March 13, 2006
LIC-06-0021

SUBJECT: Response to Request for Additional Information Related to Extension Date for Corrective Actions Regarding Generic Letter 2004-02, "Potential Impact of Debris Blockage on Emergency Recirculation During Design Basis Accidents at Pressurized-Water Reactors"

Response to Request for Additional Information Related to Extension Date for Corrective Actions Regarding Generic Letter 2004-02, "Potential Impact of Debris Blockage on Emergency Recirculation During Design Basis Accidents at Pressurized-Water Reactors"

Figure 1

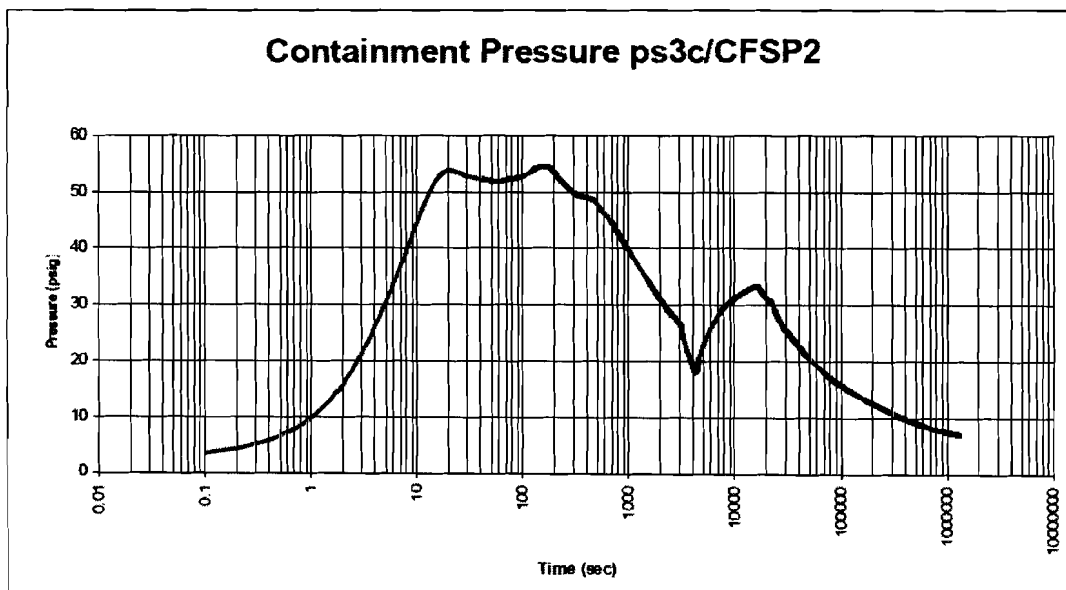
What are the physical stresses on the containment building as a result of the higher water levels using this approach?

The analysis discussed in Section 5.1.B.4.e of EA-FC-04-010, Revision 1, conservatively assumed constant post Recirculation Actuation Signal (RAS) pressure of 40 psig and showed acceptable physical stress on containment. Recently, OPPD has completed a re-analysis of the long-term containment pressure analysis in preparation for the replacement of the steam generators and pressurizer in the fall of 2006. This analysis reflects the larger steam generator and pressurizer water volumes of the replacement components. The following figure shows the results of this analysis:
